MEMORIAL PARK ELECTRICAL IMPROVEMENTS PROJECT

**COUNTY PROJECT NO. P32P1
PROJECT FILE NO. E5059**

ADDENDUM NO. 1

13 OF 17(REV)

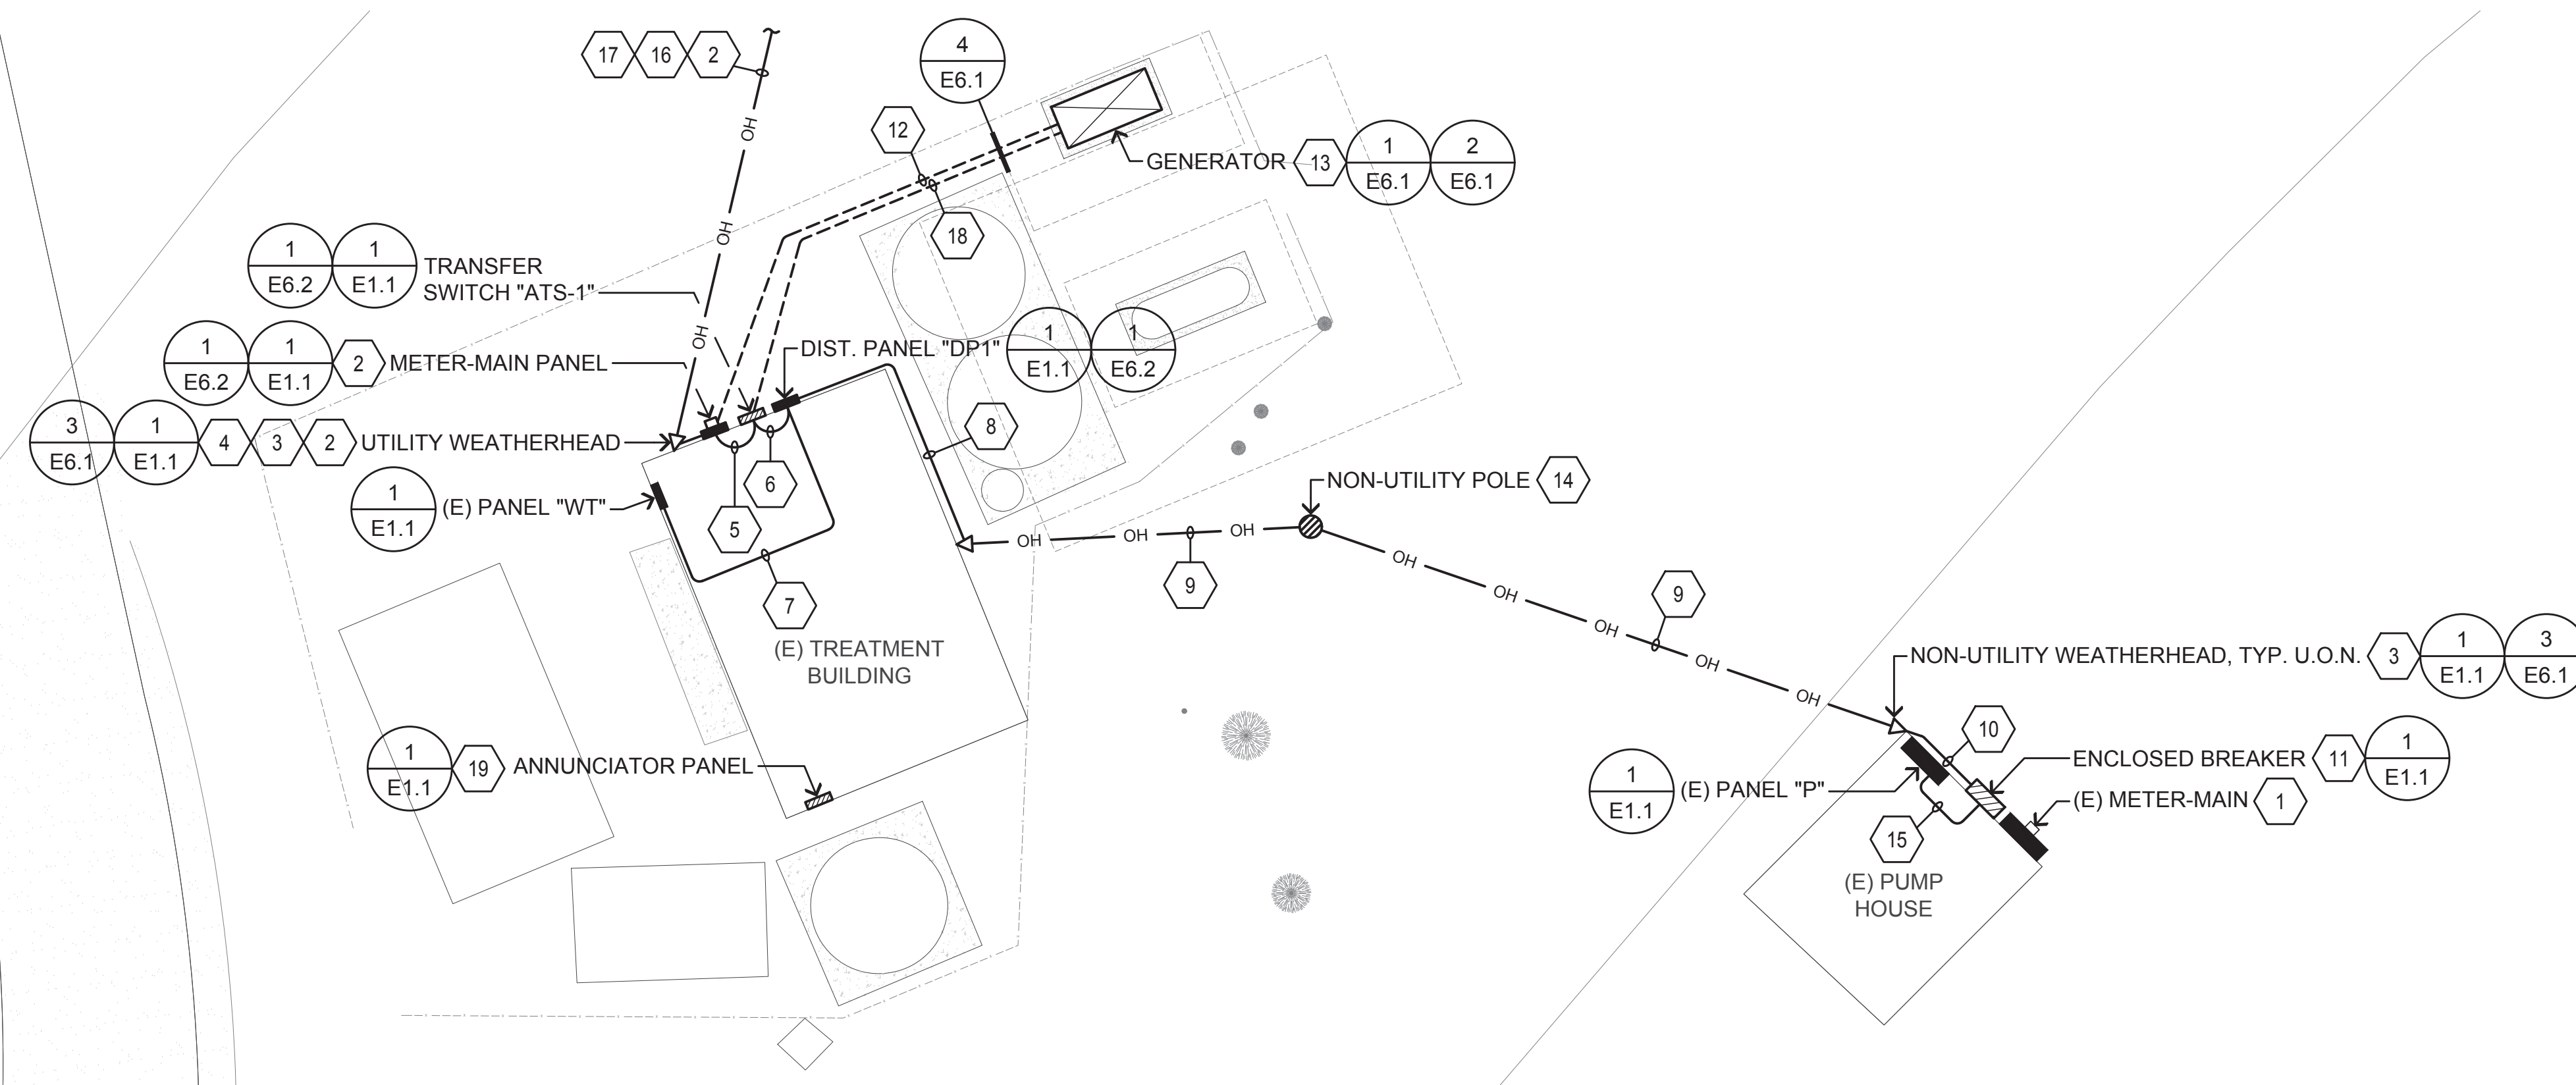
3. Sheet 13 shall be replaced in the Project Plans:

Replace Plan Sheet 13 of 17 with Sheet 13 of 17 (REV).

SHEET TITLE:
ELECTRICAL PARTIAL SITE PLAN
 - REDWOOD FLAT

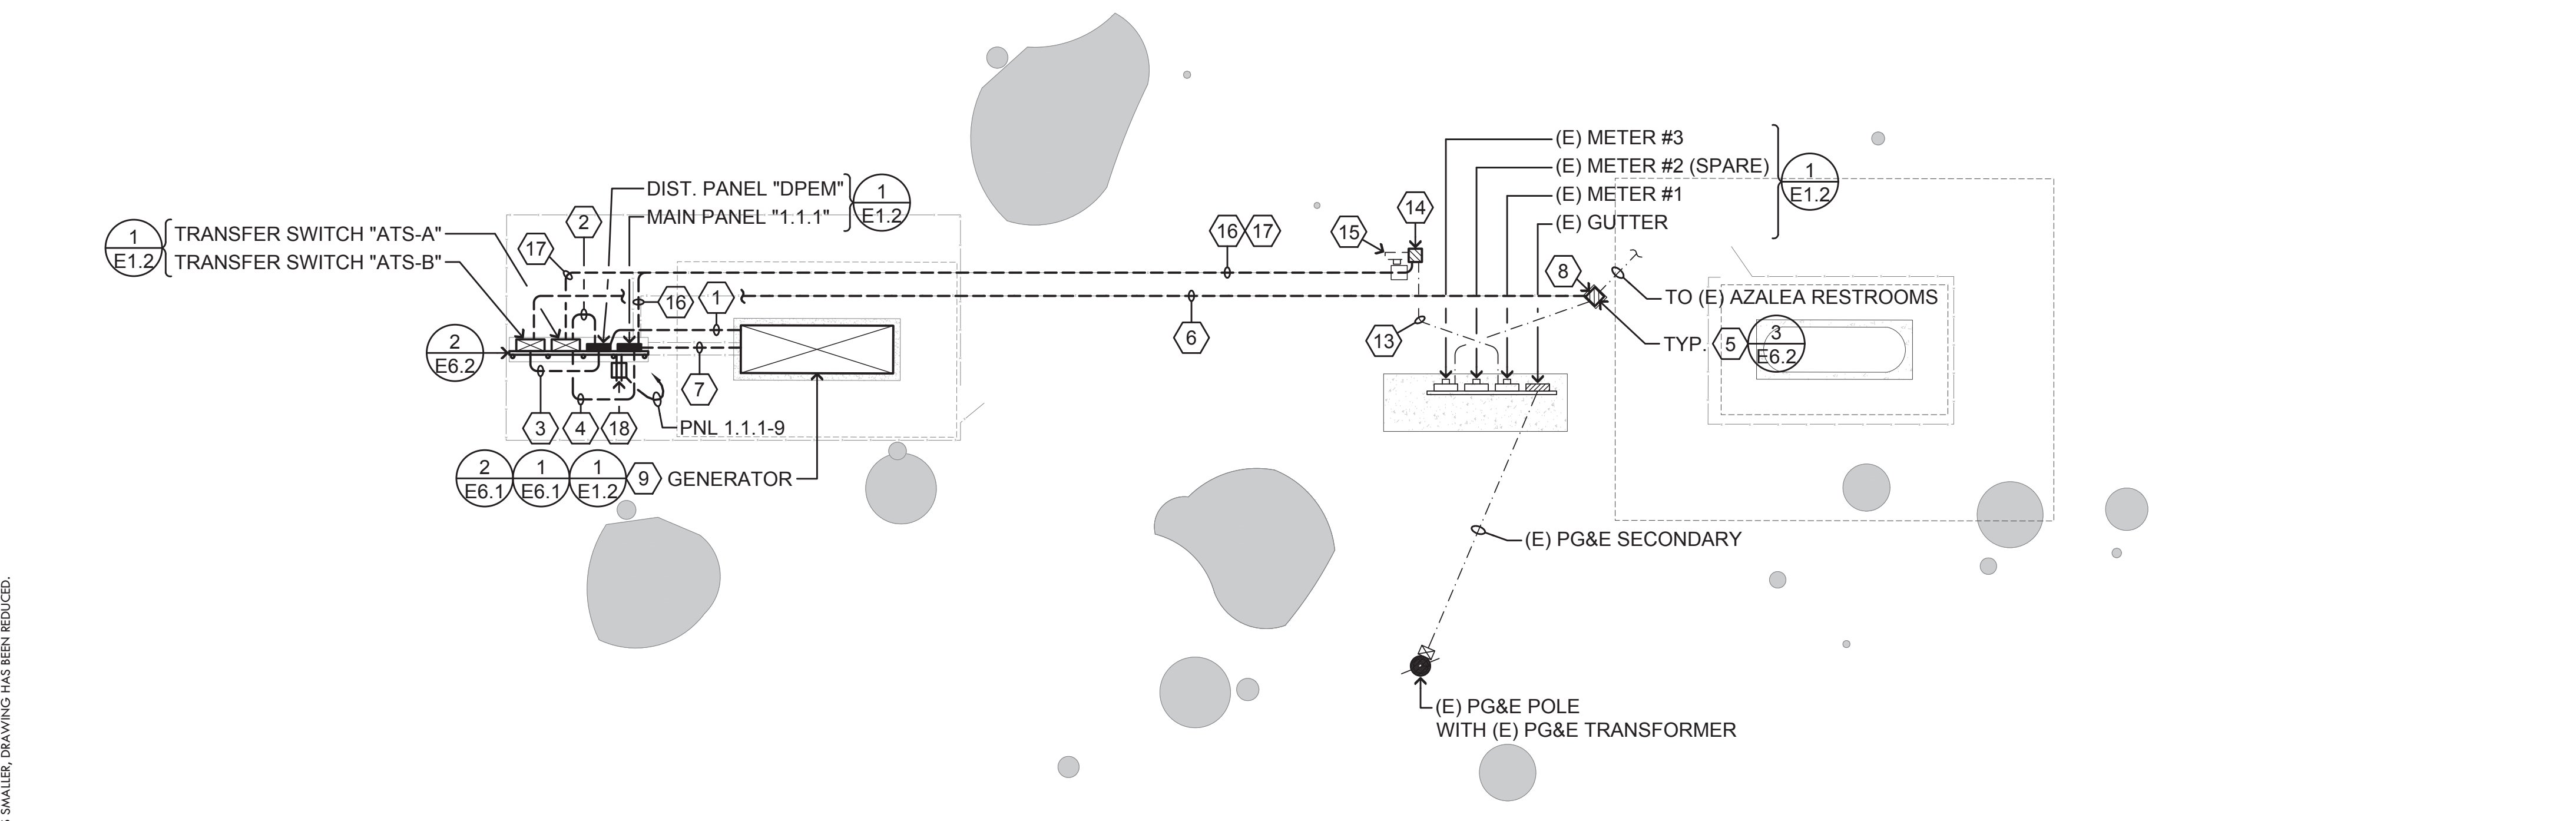
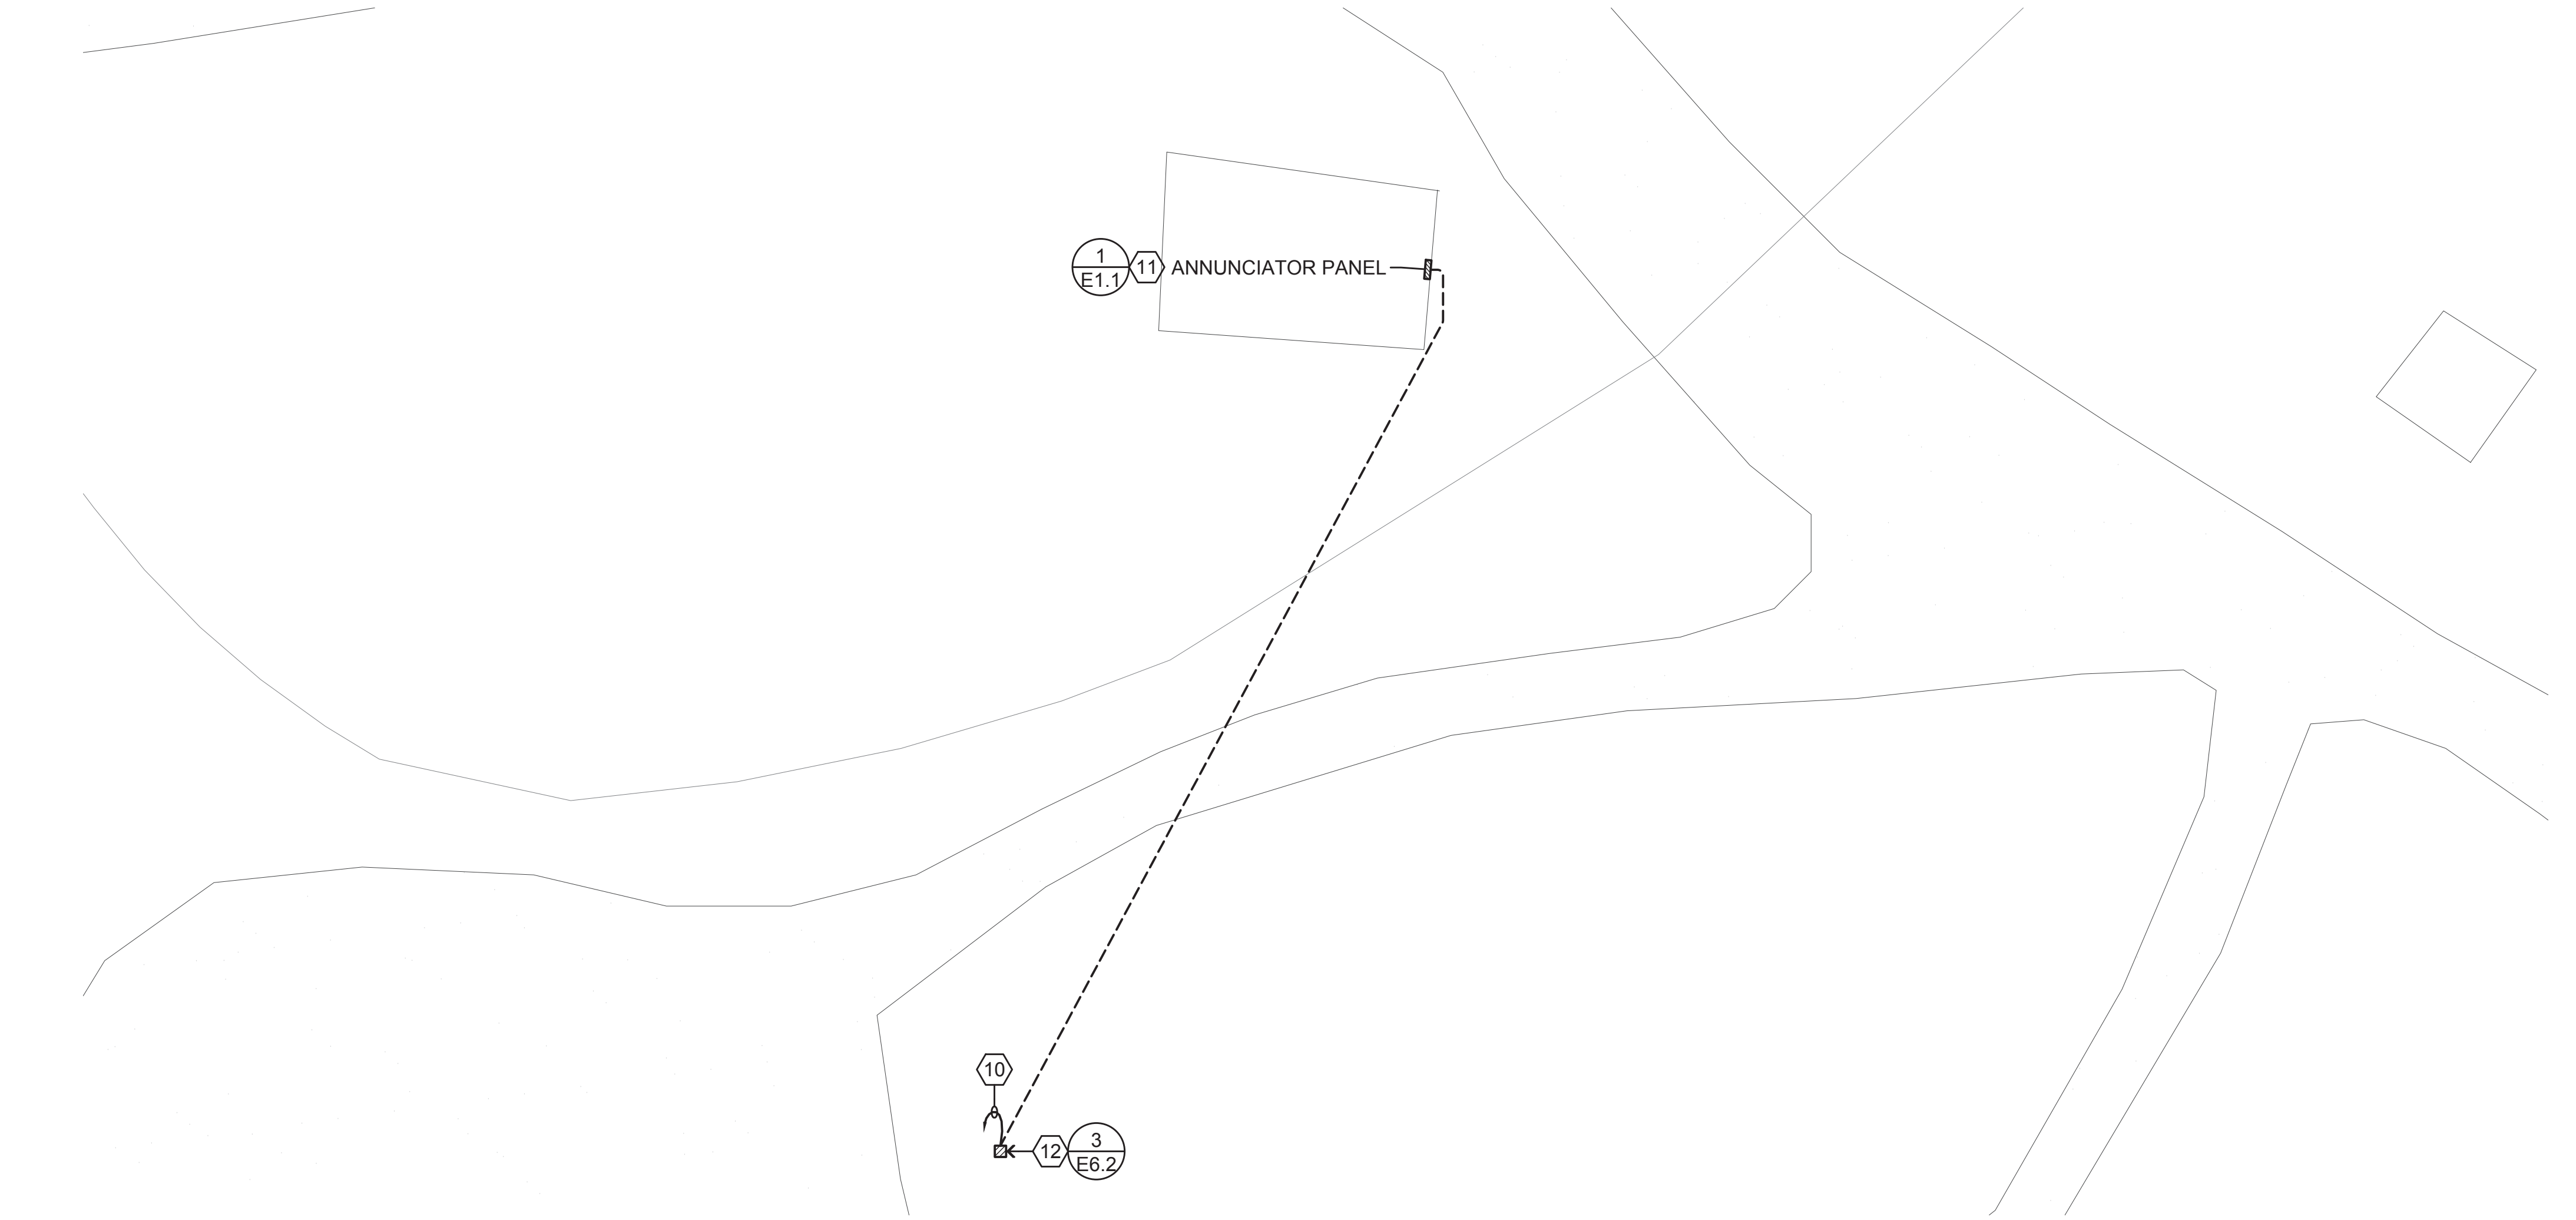
4. Sheet 14 shall be replaced in the Project Plans:

Replace Plan Sheet 14 of 17 with Sheet 14 of 17 (REV).
